The following are responses from Snake River Oil and Gas (SROG) to EPA's 10/29/2020 follow-up questions regarding SROG's 8/21/2020 response and EPA 6/10/2020 comment letter. The actual text of the EPA 10/29/2020 questions are shown in blue font, followed by SROG's response in red. Attached for reference as Attachment A is the 20201029 EPA Response to SROG.

SROG Responses to EPA Questions 1&2 of October 29, 2020

Proposed Injection Well: 1. Lower Confining Zone  
2. Depth to Injection Interval

Snake River Oil and Gas, LLC  
Willow-Hamilton Field  
Well Name: DJS Properties #2-14  
Payette County, ID  
**Proposed P&A - Post Injection**  
(Proposed work is shown in red)  
Currently T&A'd  
API# 11-075-20023

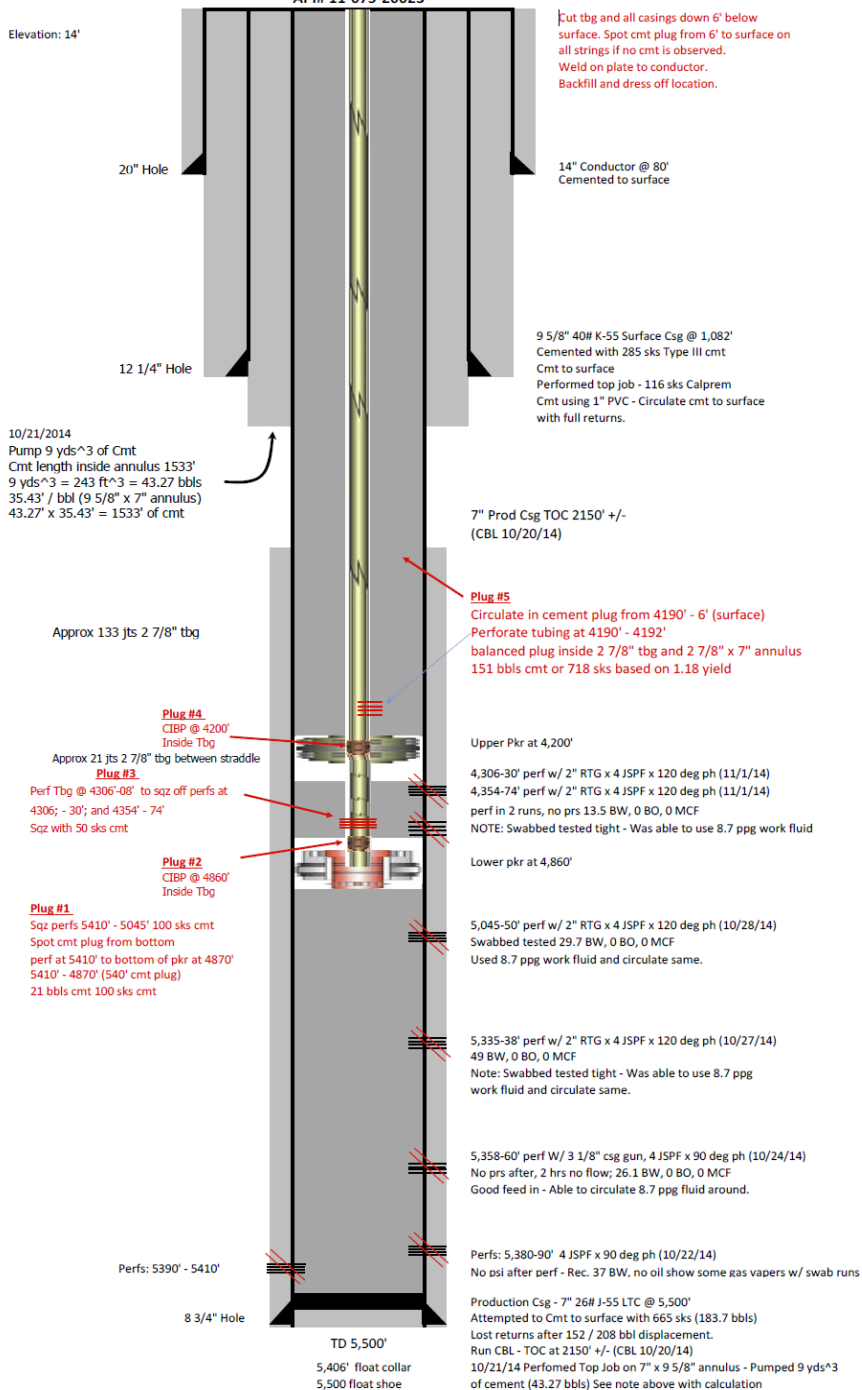
3. The latest permit application submitted on April 16, 2020 contained a well plugging and abandonment (P&A) schematic indicating two cement plugs would be set in DJS 2-14. It also included a third-party cost estimate of \$66,000 to plug and abandon the well (presumably, by the method prescribed in the P&A plan). Your August 21, 2020 response to EPA's questions indicates that the P&A plan has changed, and that now the plan calls for the entire wellbore will be filled with cement. Please clarify by submitting:
  - a) The most recently prepared and signed 7520-15 form,
  - b) A proposed P&A schematic that matches the work proposed on form 7520-14,
  - c) A cost estimate that includes P&A procedures that match the plan and schematic.

The method for P&A should match in all three documents.

Additionally, please detail P&A procedures that will be put in place to ensure safe plugging of this well without a drilling rig on-site (considering possible gas accumulation).

Please see Attachment C for a completed and signed Form 7520-19. This form was generated and attached after a discussion with Mr. Evan Osborne regarding the latest forms desired for this purpose by the EPA. Sub-attachments to this Form are: (1) a proposed P&A schematic, and (2) an updated cost estimate.

1. Move in and rig up electric wireline unit and cement unit.
2. Bleed any gas accumulation in tubing or on backside to temporary flare as necessary and fill casing with water. Establish injection rate with water down tubing and then pump cement down tubing into injection perforations using 100 sacks (23 barrels) of cement, leaving cement plug #1 over the interval 5410-4870'. [Plug #1 = 5410-4870']

3. Set cast iron bridge plug (CIBP) inside 2 7/8" tbg at 4,860' and pressure test same. [Plug #2 = CIBP @ 4860']
4. Perforate tbg at 4,306' - 4308'. Sqz perms between straddle pkrs at 4306' - 4330'; 4354' - 4374' with 50 sks cmt. [Plug #3 = 4306' - 4374']

5. Set CIBP inside 2 7/8" tbg at 4200'. [Plug #5 = CIBP @ 4200']
6. Perforate 2 7/8" tbg at 4190'-4192. Circulate in 151 bbls cement plug from 4190' - 6' (leaving a balanced plug inside the tubing and the tubing / casing annulus). [Plug #5 = 4190' - 6']

7. Rig down cement unit and electric wireline unit and move off location. Wait on cement for 24 hrs.
8. Move in back-hoe. Nipple down 2 9/16" wellhead tree. Dig bell hole around wellhead approximately 8' below ground surface. Move in and rig up welder. Cut windows on 14" conductor and 9 5/8" casing at 6'. Make primary cut on 9 5/8" casing, 7" casing, and 2 7/8" tubing. Remove casing head and tubing head along with the cut pieces of casing and tubing. Cut 14" conductor at 6' and remove same. Make final cuts flush on all strings. Weld on 14" steel top closure plate. Weld API Number, date, location into plate. Backfill bell hole. Restore location.

ELAN Log Comparison to  
Quad Combo Log – ML #1-11

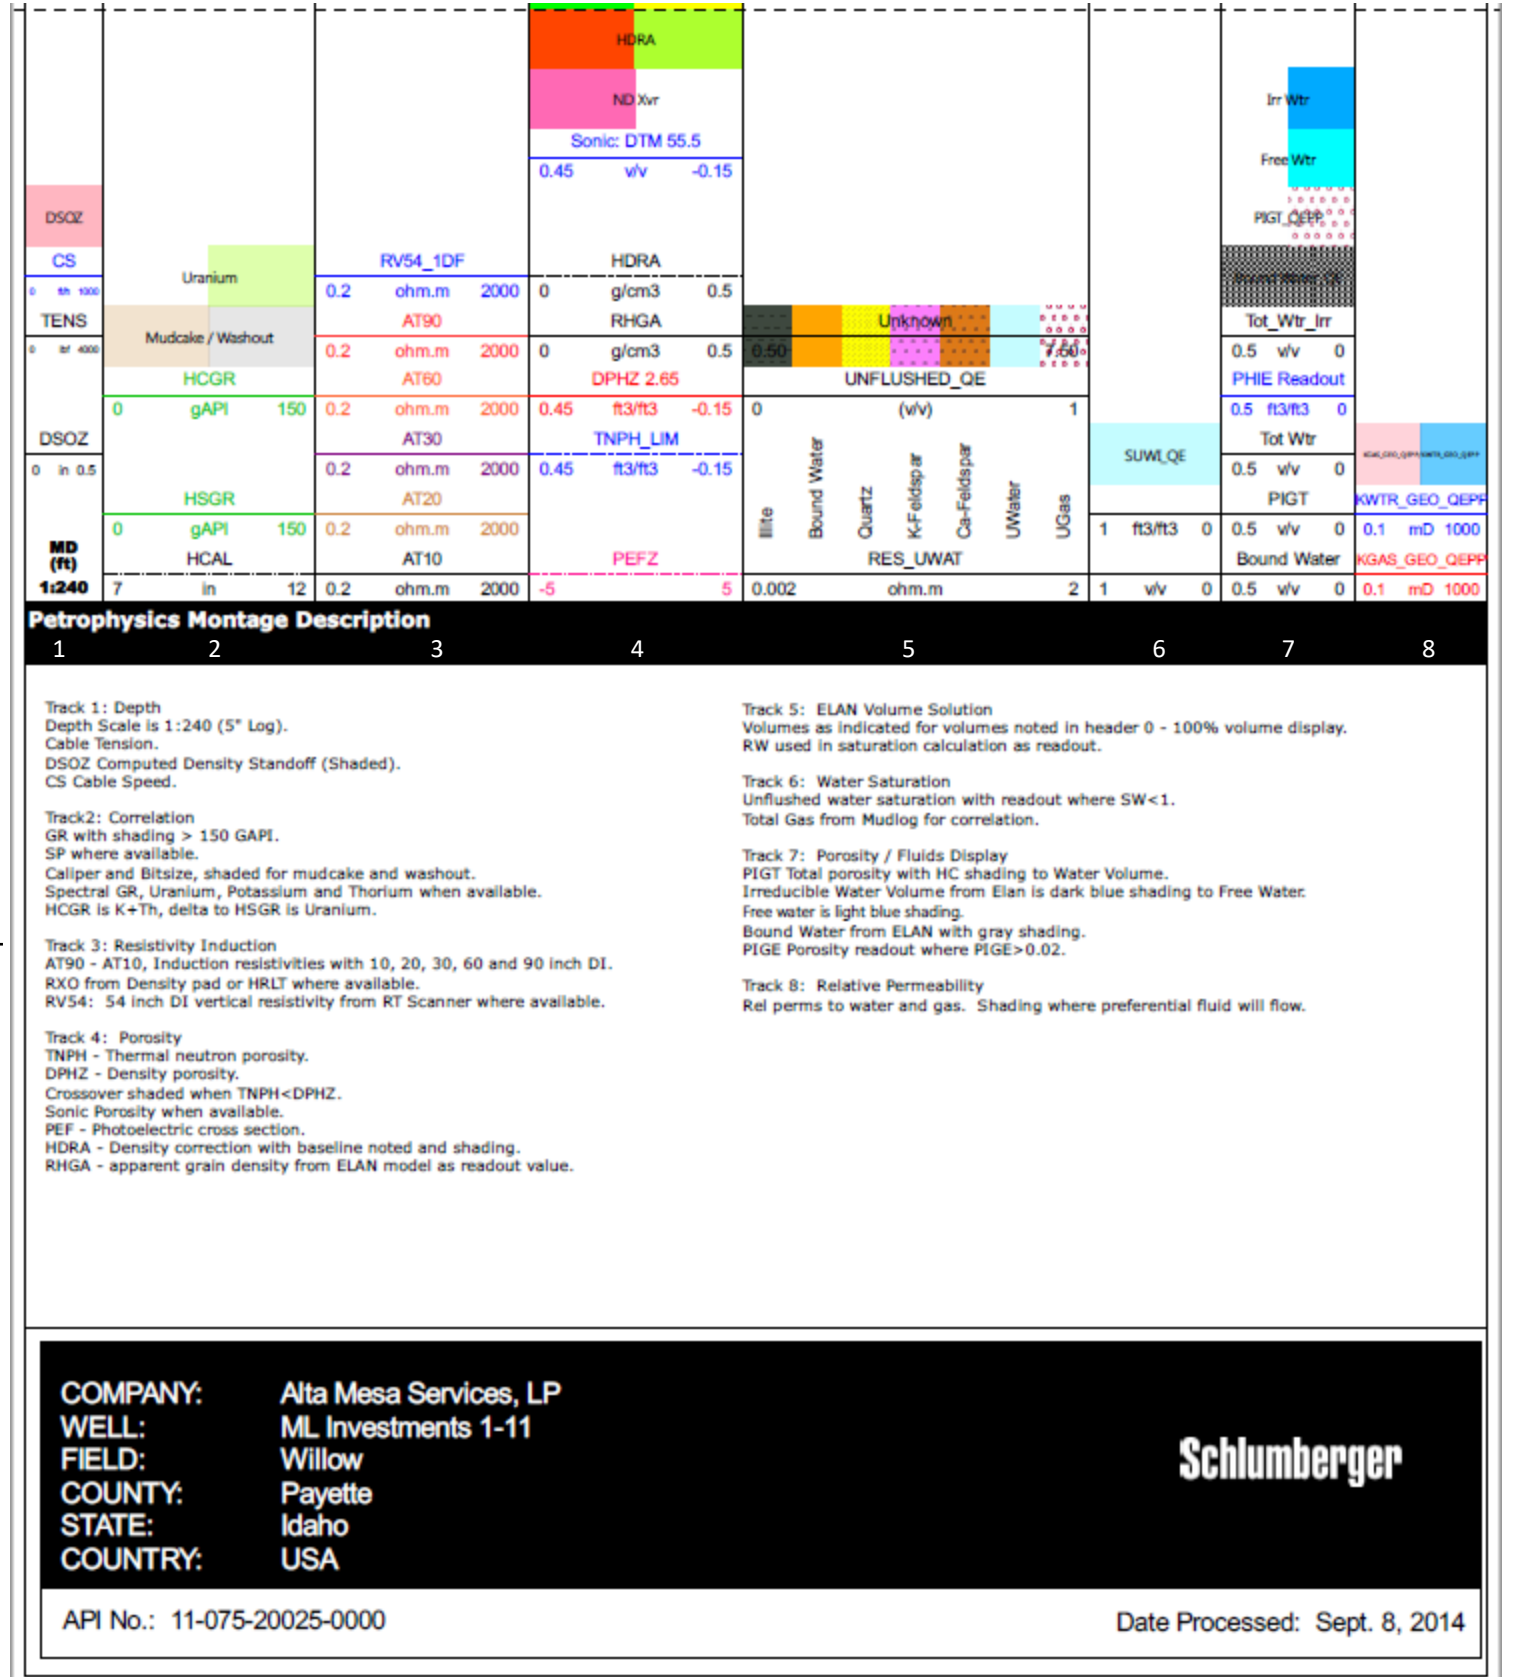
**Attachment D, Slide 4** is a display comparing the typical quad combo log presentation to the processed ELAN log. This exhibit is shown as the majority of the area wells have

quad combo logs only and have not had ELAN logs calculated for them. The slide also shows the cyclic depositional nature of the sands and intervening claystones.

Note that the sands are colored yellow and numbered, the claystones are gray. The sands are characterized by lower gamma-ray readings, higher resistivities, and neutron/density porosity values that track each other well, both reading 20 to 25% typically.

The Claystones are characterized by higher gamma-ray readings, low resistivities in the 1 to 3 ohm range, and neutron and density porosity values that are highly discordant. Regarding the Quad Combo log footer (Oval highlights in lower right part of the left log display) the scale shows the porosity values are 0 % on the right, to 0.6 (60%) on the left. There are 10 divisions and each represents 6 porosity units. The Density porosity values are the red curve, the neutron porosity curve is blue. Focusing on the 8/9 Claystone interval immediately above the footer (5260' to 5450'), the Neutron values (blue) are reading 5 to 6 divisions or about 30-36%, the density values (red) are 2 divisions or around 12%. As discussed above, the Neutron log infers porosity by measuring the presence of Hydrogen molecules, and is therefore wildly optimistic about porosity values due to the significant presence of bound and trapped water in the claystones. This phenomenon of divergence of the density and neutron curves provides a useful tool to identify the claystone intervals.

STRATIGRAPHIC CROSS-SECTION

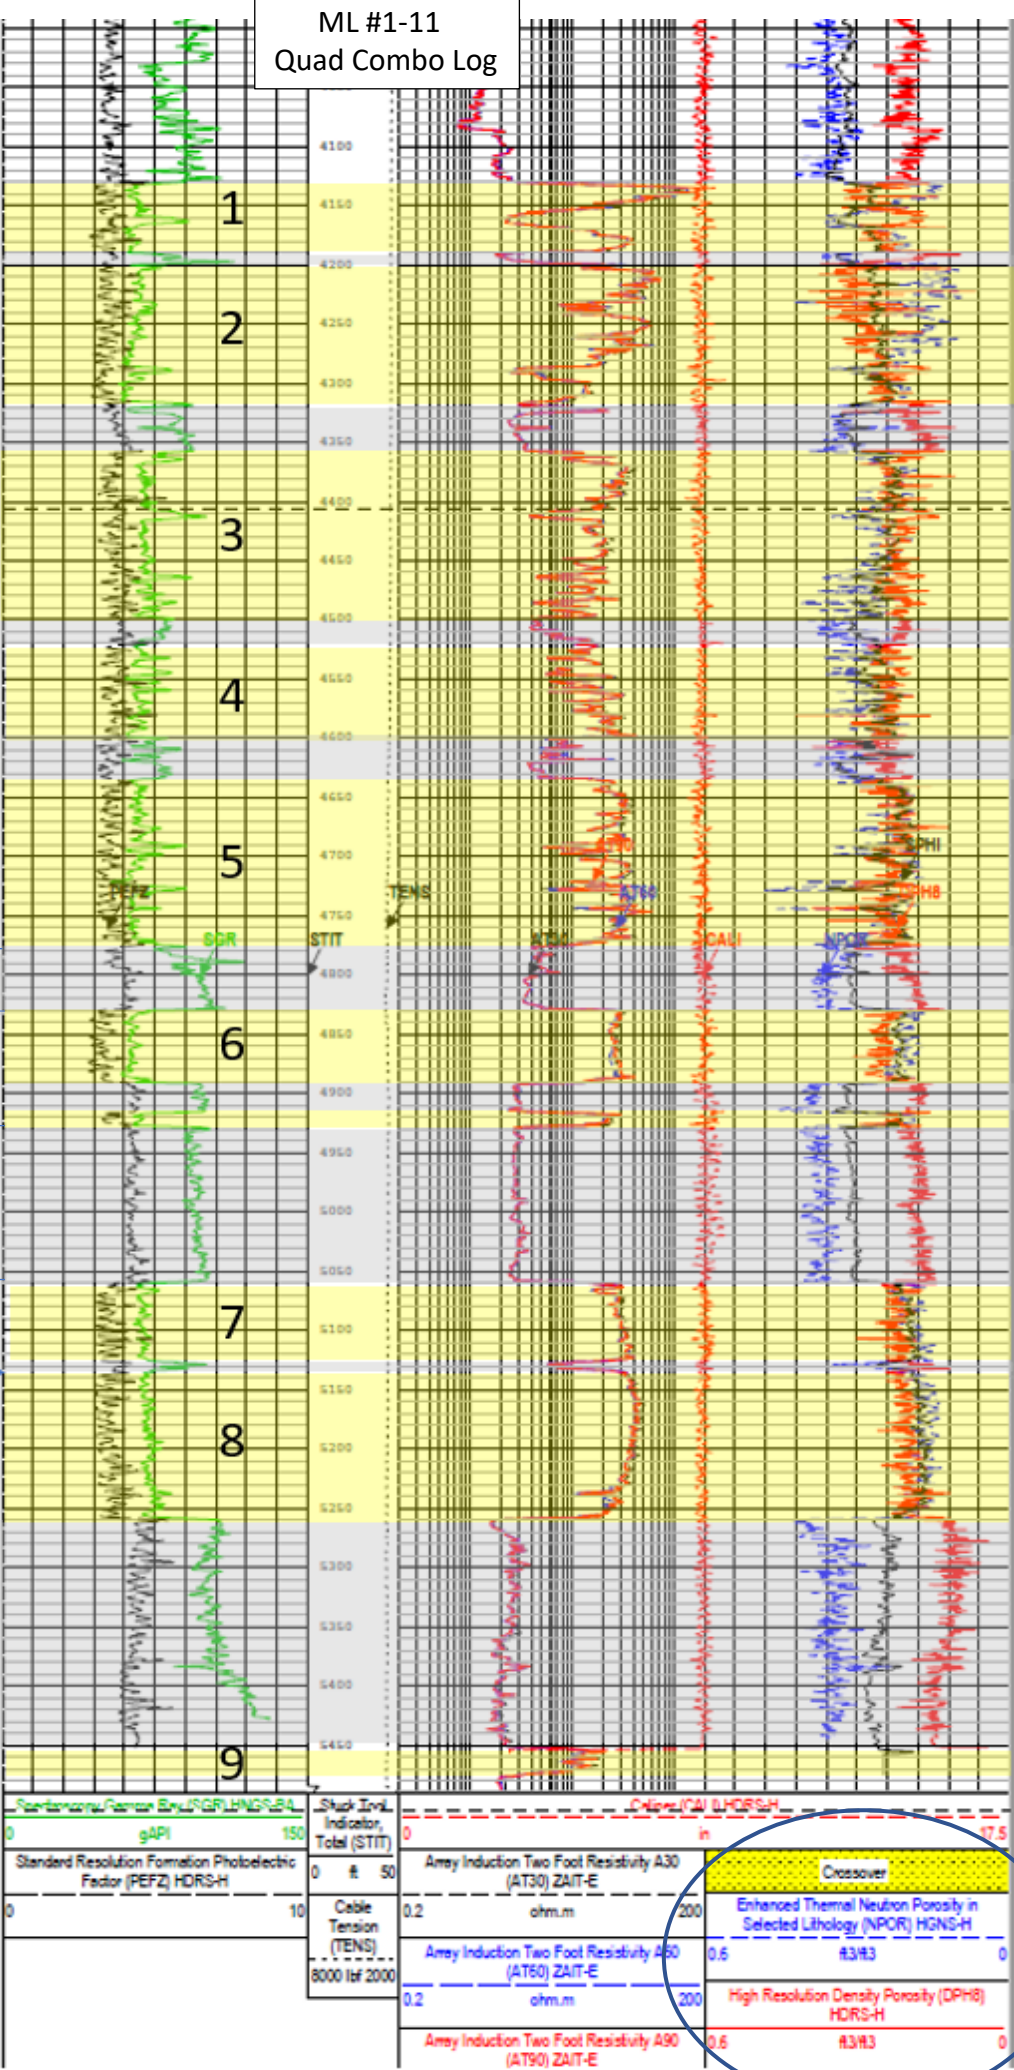
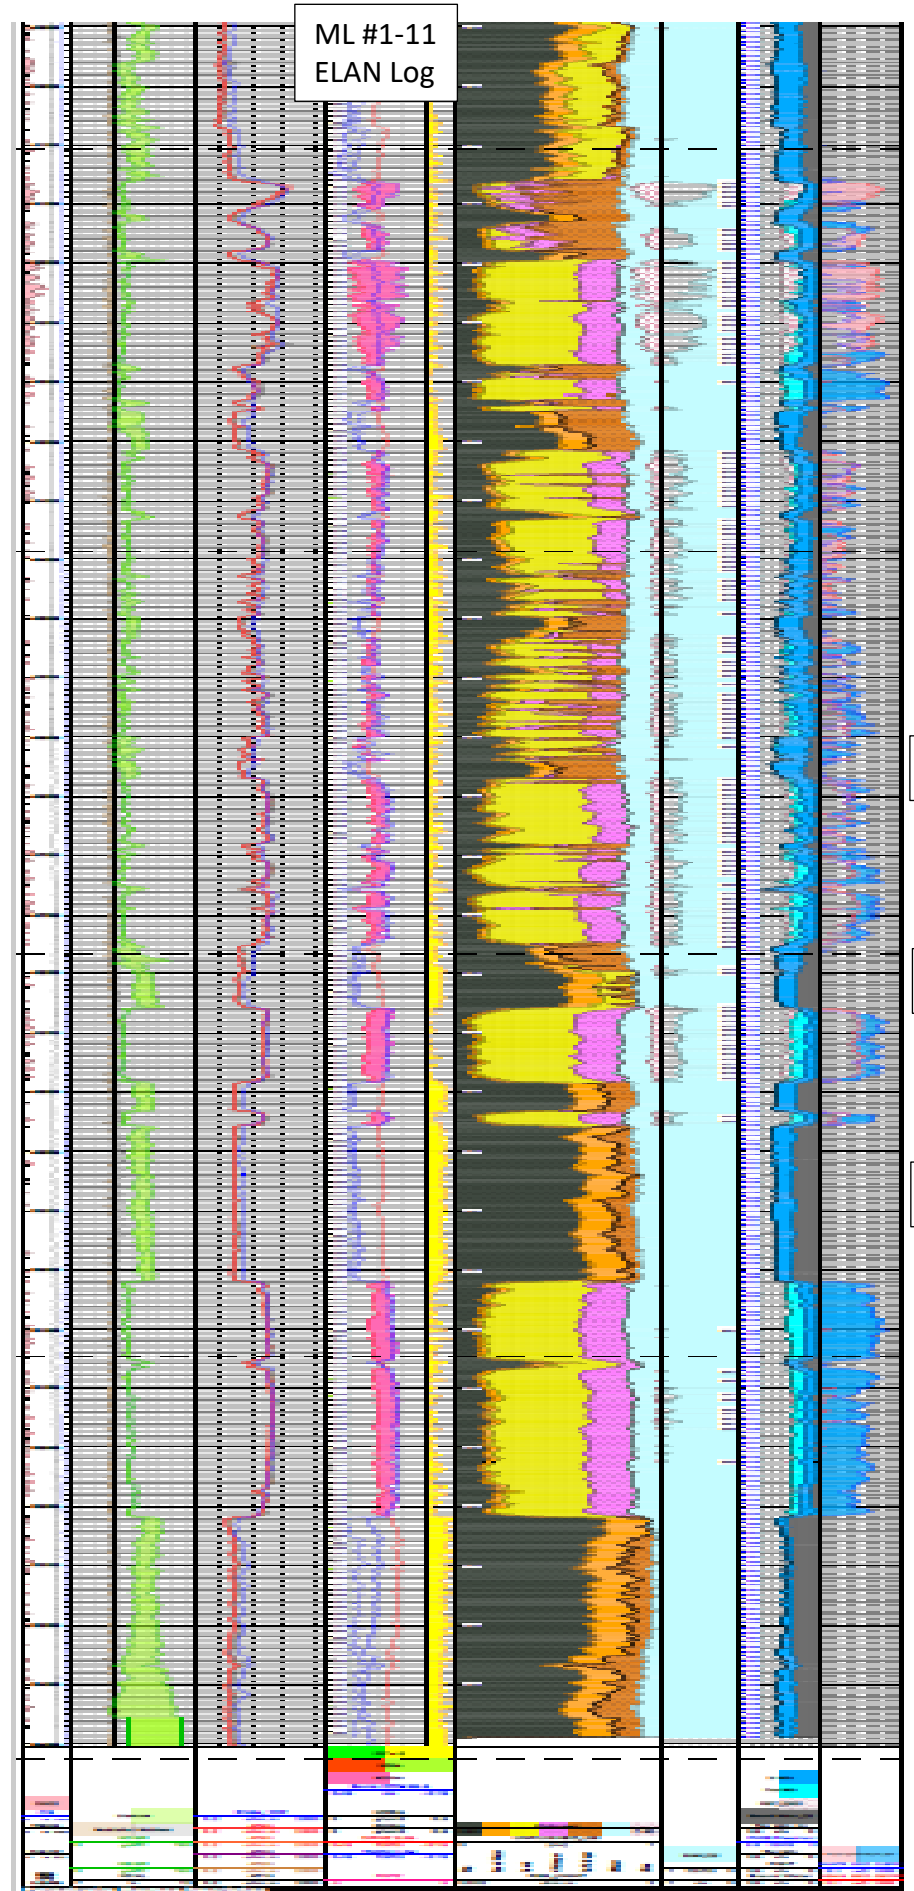
1. Based on the regional faulting and stratigraphic dip across the Western Snake River Plain, it seems improbable that specific claystones seen in the Ore Ida well correlate with the lower confining zones below the bottom of the DJS 2-14 wellbore. Nearby wellbores, including ML 1-11, provide evidence of claystones between Willow Sands, but local unconformities may exist across faults. Please identify a lower claystone seal existing below the proposed injection zone that is competent and continuous across Fault Block E. Also, please indicate the depth of this lower confining zone as it occurs across the field. (This information will be needed for the next question, too).

*Attachment D, Slide 5* is a stratigraphic cross-section between the ML 1-11 well and the DJS 2-14 well. The logs are hung on a datum at the top of Sand 3. Stratigraphic cross-sections are useful to show the correlations between stratigraphic units as they were deposited. Note that all the sands and claystones correlate very well, even as the wells are 3352' apart. The DJS 2-14 well reached total depth just at the top of the 6/7 Claystone at 5500' TD. The 6/7 Claystone is just below TD, as it is present in every well in the field area that drilled deep enough to penetrate the interval. This is shown on subsequent slides.
